**Subject: Update to Proposed Investigation Project at**  
**Former Gasoline Station**  
**508 East Lewelling Boulevard**  
**San Lorenzo, California**

Mr. Amir Gholami  
Alameda County Environmental Health Department  
1131 Harbor Bay Parkway, Suite 250  
Alameda, CA 94502**Subject: Addendum to Workplan for Soil and Groundwater Investigation  
508 East Lewelling Boulevard, San Lorenzo, California**

**SITE PLAN**

FORMER SERVICE STATION  
508 E. Lewelling Boulevard  
San Lorenzo, California

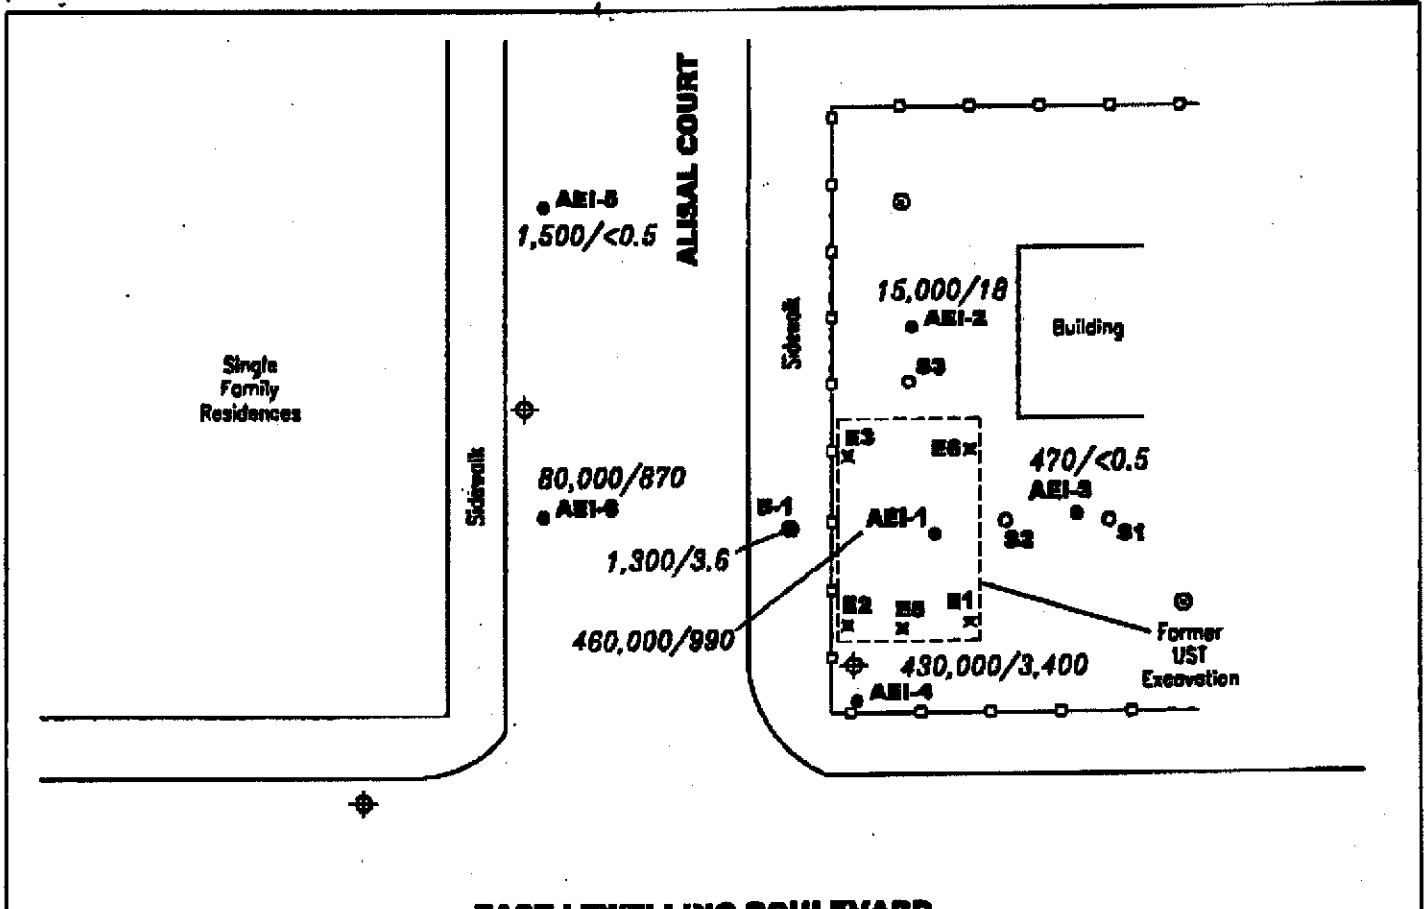
Three additional soil borings will be drilled in the approximate locations shown on the attached Figure 2. Grab groundwater samples will be collected from each boring and analyzed for the presence of petroleum hydrocarbons including MTBE.
